Technical Service Bulletin: tsb103946

Connecting Rod Reuse Guidelines at Rebuild or Repair

This Service/Parts Topic supercedes Service/Parts Topic 06T1-34. Replace Service/Parts Topic 06T1-34 with this Topic.

This illustration shows the difference between a straight split connecting rod (1) and an angle split connecting rod (2).

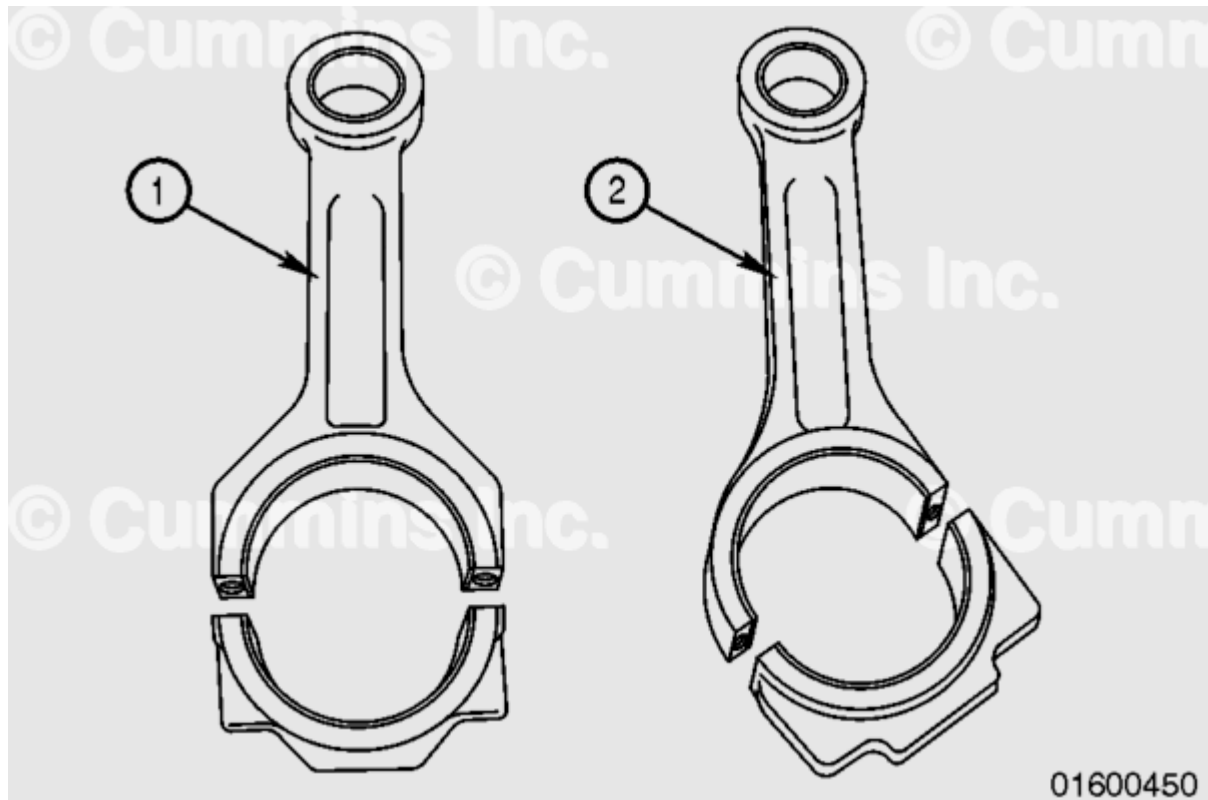
Angle split connecting rods from QSK45/60 engines in fracturing rigs, excavators, loader, and mechanically driven haul trucks should **not** be reused at rebuild or repair, regardless of hours. Angle split connecting rods from QSK45/60 engines in electrically driven haul trucks, power

generation, marine or other applications should only be reused at rebuild or repair if the connecting rods have less than 10,000 hours on them. If the connecting rod does **not** pass the reuse guidelines, it **must not** be reused, regardless of hours.

Straight split connecting rods from any application can be reused at rebuild or repair, regardless of hours, provided they pass reuse guidelines.

Note : Angle split and straight split connecting rods **can not** be mixed within an engine. All connecting rods must be the same design. Straight split connecting rods **can not** be installed into engines built prior to Engine Serial Number (ESN) 33172060, unless they have had a cylinder block upgrade.
